Our Reference: 091.5018/WSCC/010725

Response to LLFA objection letter dated 06 May 2025

Thank you for your comments dated 6th May 2025 regarding the application: DC/25/0102 Land at Campsfield Linfield Close Southwater. The comments can be found in **Appendix A**.

RE: DC/25/0102 Land at Campsfield Linfield Close Southwater

| B | 06.11.14 | Redline updated | | | SCALE: 1:1000 (A1 ORIGINAL) | DRAWING: Existing Site Survey |  OSP ARCHITECTURE |

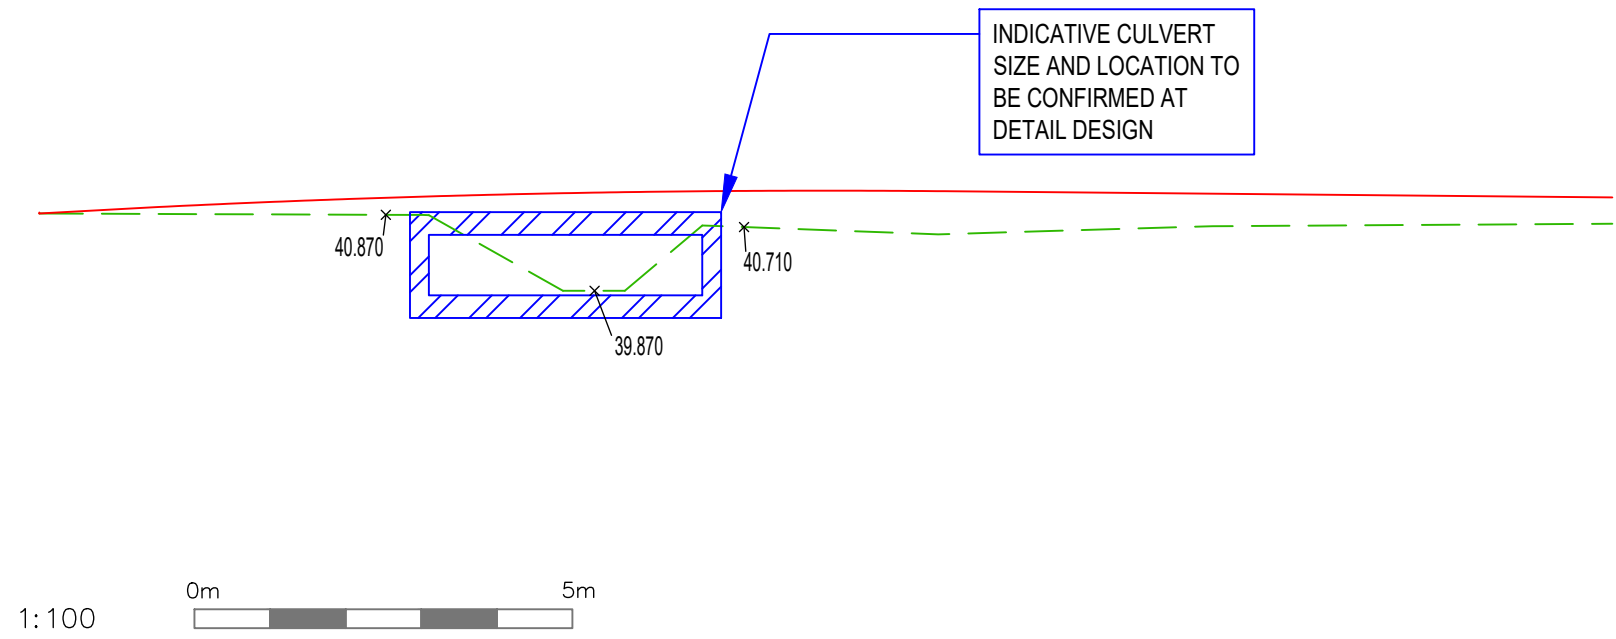
In relation to the above, we note there is a surface water flow path intersecting the proposed access road for the development. It must be demonstrated that users of the site have safe access in a design storm (1 in 100 years plus climate change) and the flow path will be maintained post development.

As discussed in the meeting, we are submitting a detailed topographical survey (**Appendix B**) from the previously developed site located directly to the North of the ditch. The survey extends across the full length of the ditch, and we trust that it is sufficient to demonstrate the existing ditch profile. In addition to the updated topographical survey, we have prepared a cross-section showing the profile of the existing ditch together with an indicative culvert arrangement which has been added to the drainage strategy drawing 091.5018.0501-P03. The culvert size and location will be confirmed at the detailed design stage. This plan can be seen in **Appendix C**.

PROPOSED DRAINAGE STRATEGY
SHEET 1

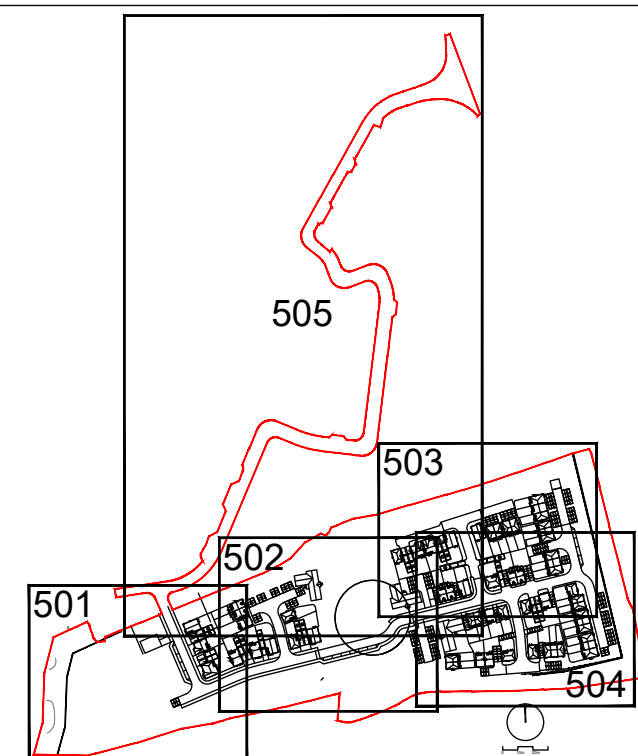
Please provide a cross section for the proposed earthworks surrounding the attenuation basin adjacent to the Western boundary.

The drainage layout provided indicates that the above basin will have an available freeboard of 79mm in the 1:100 plus climate change event, however as per the CIRIA SuDS Manual there should be 300mm of clear freeboard above the top water level in this scenario.

As confirmed in the meeting, drawing 091.5018.0501-P03 has been updated to include a note confirming that the attenuation basin will be constructed with earthworks at a gradient of 1:3 to tie into the existing ground.

This point was discussed during our meeting, and it was agreed that our proposed design and explanation—that the nearest dwellings to the basin have a finished floor level more than 3 m above the basin’s top water level—was deemed acceptable in this instance.

Additionally, section 23.4.5 of the SuDS Manual states: “... for smaller ponds, there may be no need for a freeboard, provided the risk to people and property has been evaluated.” Given that this is a small pond, and that any exceedance would flow into the woodland safely away from any development, the design is compliant with the SuDS Manual. At the detailed design stage, a suitable overflow route will be incorporated into the pond, in accordance with the SuDS Manual, to ensure the structure is protected during any exceedance event.

PROPOSED BASIN
MANHOLE REF: 'S35'
WATER VOLUME: 1140m³
TOP LEVEL: 37.8m
BASE LEVEL: 35.8m
SIDE SLOPES: 1:3
TWL: 3.3%AEP +40%cc: 37.281m (519mm FREEBOARD)
TWL: 1%AEP +45%cc: 37.645m (157mm FREEBOARD)
TOTAL CATCHMENT AREA BEING TAKEN: 14202m²

BASIN EARTHWORKS 1:3
TO TIE INTO EXISTING
